ITEM: 6.6	REPORT SUMMARY MINOR VARIANCE APPLICATION FILE NUMBER A065/25
-----------	---

CITY WARD #:	5
APPLICANT:	Oren & Sandra Shemesh
AGENT:	Jarvis Design Firm
PROPERTY:	41 Idleswift Drive, Thornhill
ZONING DESIGNATION:	See Below
VAUGHAN OFFICIAL PLAN (2010) DESIGNATION:	Vaughan Official Plan 2010 ('VOP 2010'): "Low Rise Residential"
RELATED DEVELOPMENT APPLICATIONS:	N/A
PURPOSE OF APPLICATION:	Relief from the Zoning By-law is being requested to permit an extension to the existing garage. Relief is also being requested to permit a circular driveway with access to two roads and to increase the cumulative width of the circular driveway.

GARAGE ADDITION	
41 IDLESWIFT DR. THORNHILL, ON.

A0.01

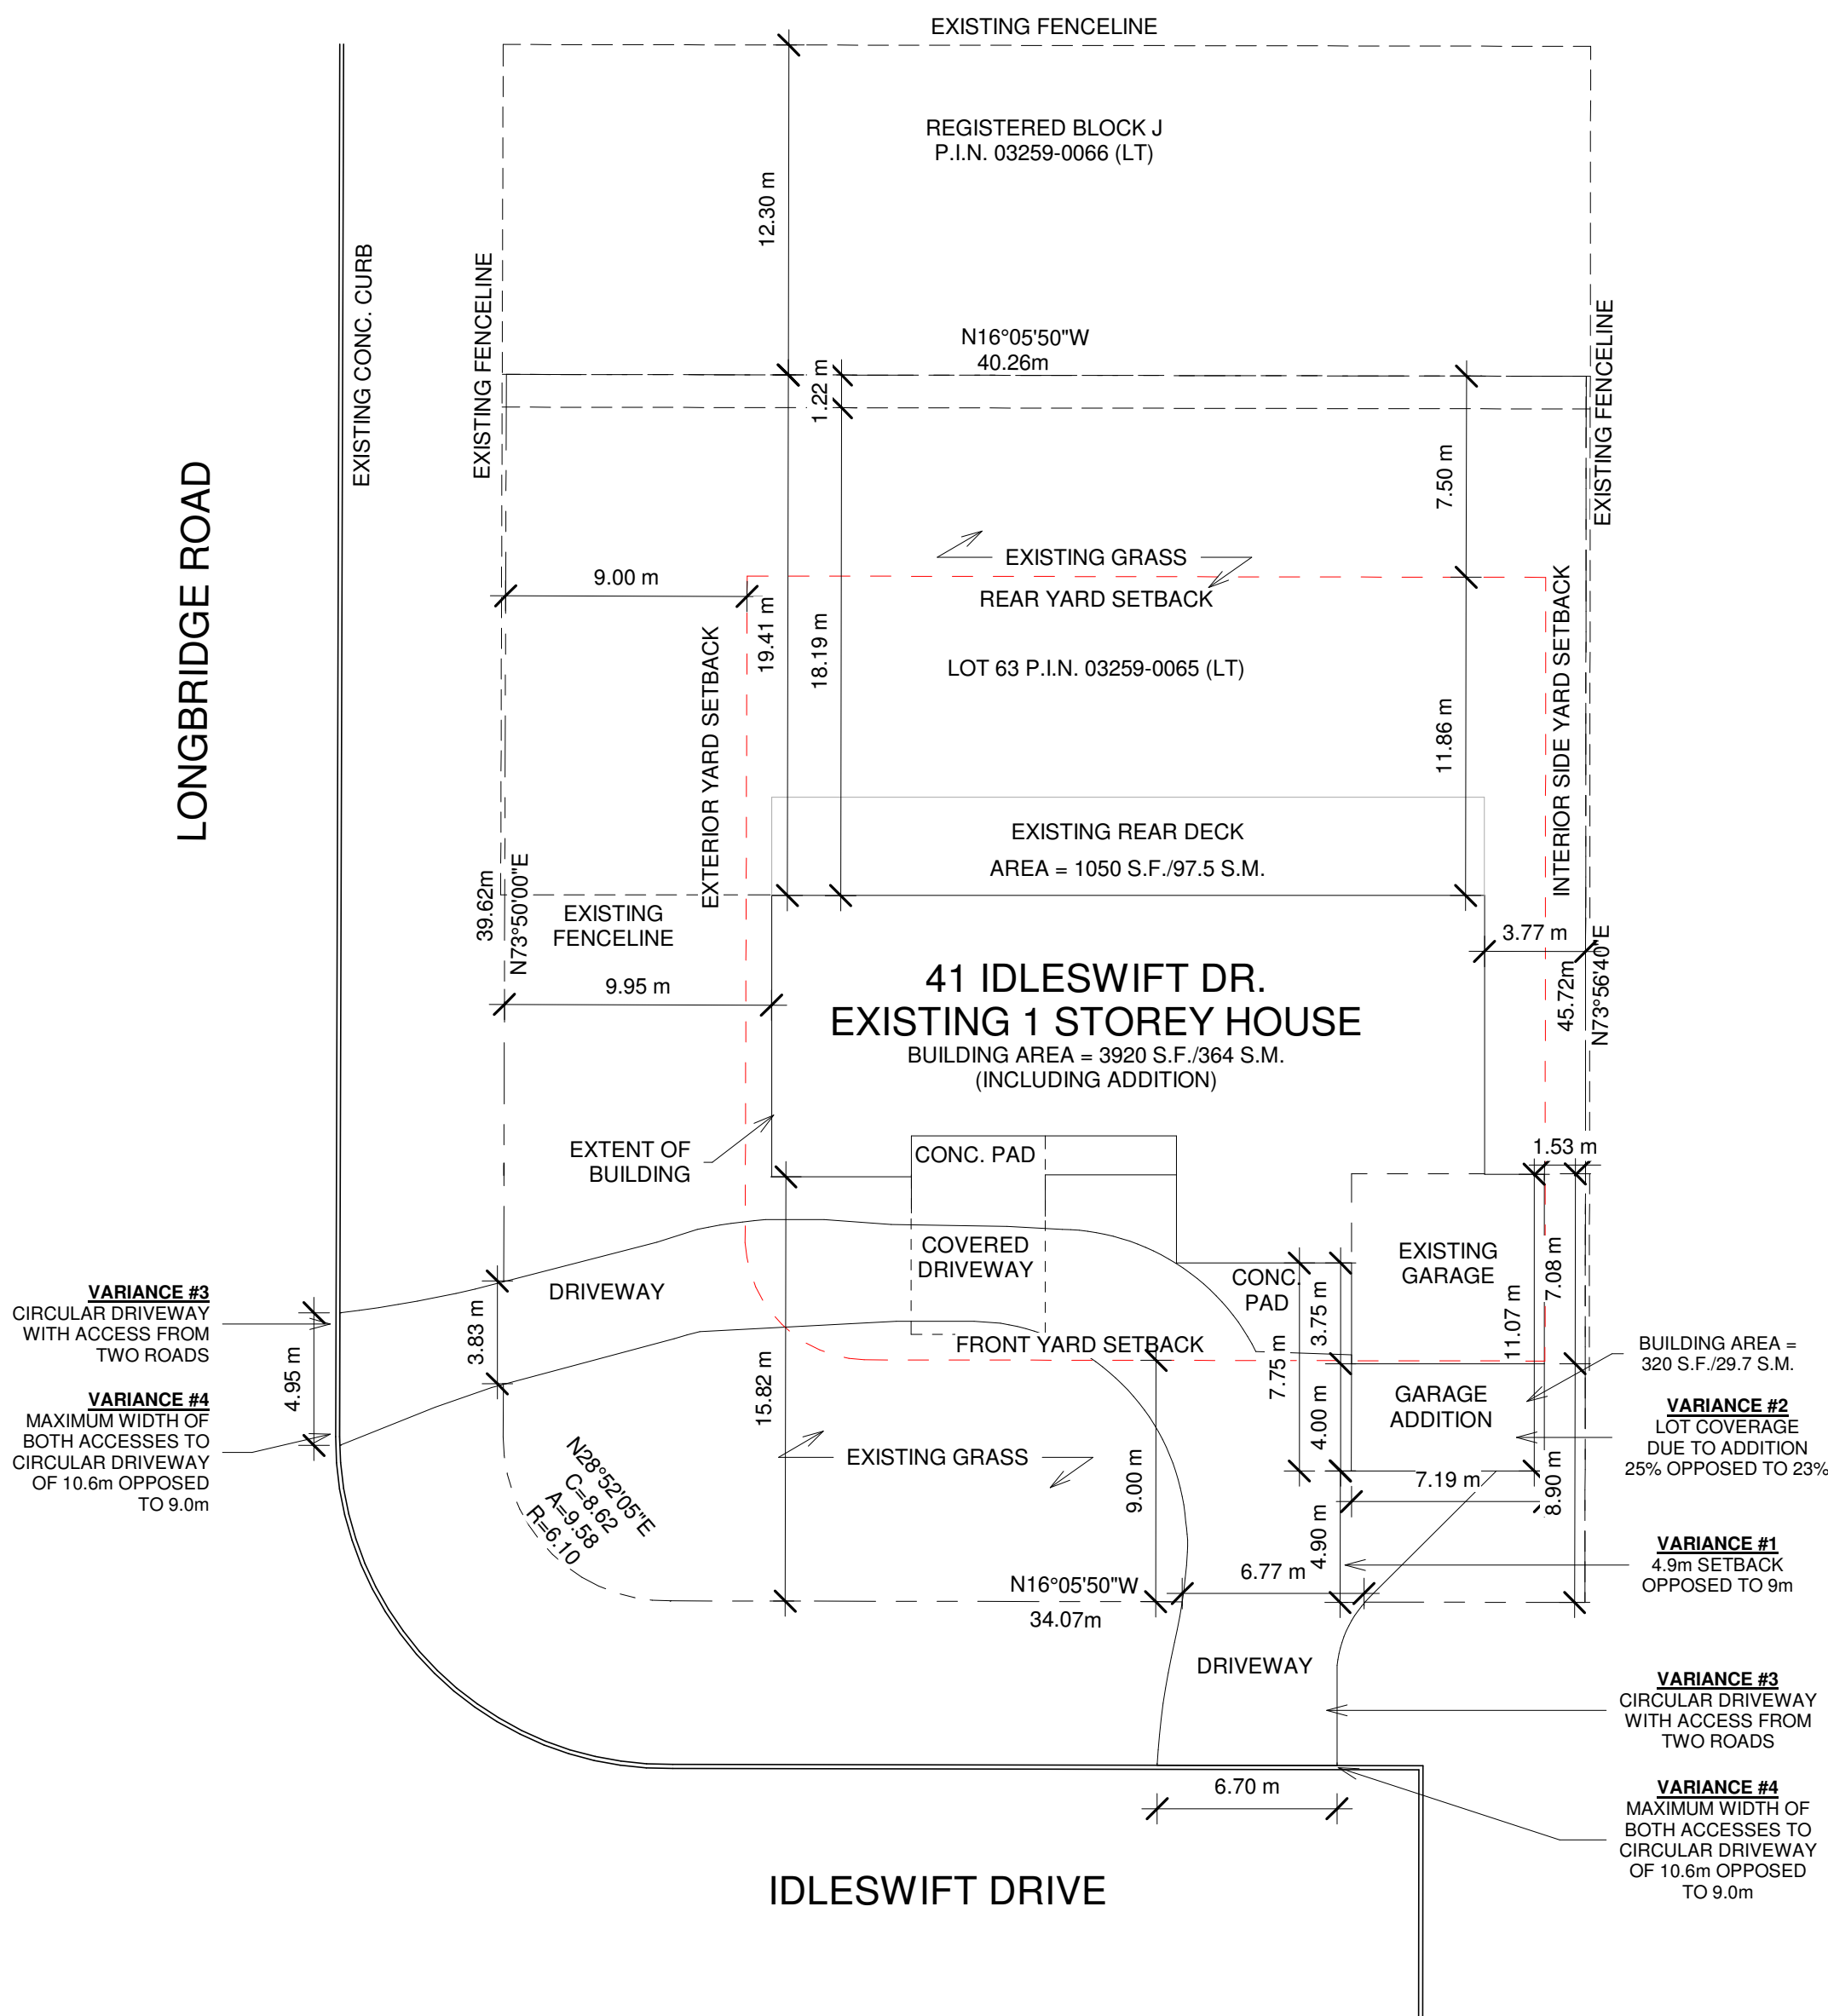
#	Zoning By-law 001-2021	Variance requested
1	The minimum required front yard is 9.0m . Section 7 table 7-3	To permit a minimum front yard of 4.9m .
2	The maximum permitted lot coverage is 23%. Section 7 Table 7-3 note 2	To permit a maximum lot coverage of 25% .
3	Both accesses to a circular driveway shall be located on the same lot line. For clarity, a circular driveway shall not provide access to more than one road . Section 6.7.4 2	To permit a circular driveway with access from two roads .
4	The maximum cumulative width of both accesses to a circular driveway, as measured at the street line, shall be 9.0 m . Section 6.7.4 4	To permit the maximum cumulative width of both accesses to a circular driveway of 10.6m .

General Comments	
1	The applicant shall be advised that additional variances may be required upon review of detailed drawing for building permit/site plan approval.
2	The subject lands may be subject to Ontario Regulation 166/06 (TRCA - Toronto and Region Conservation Authority).
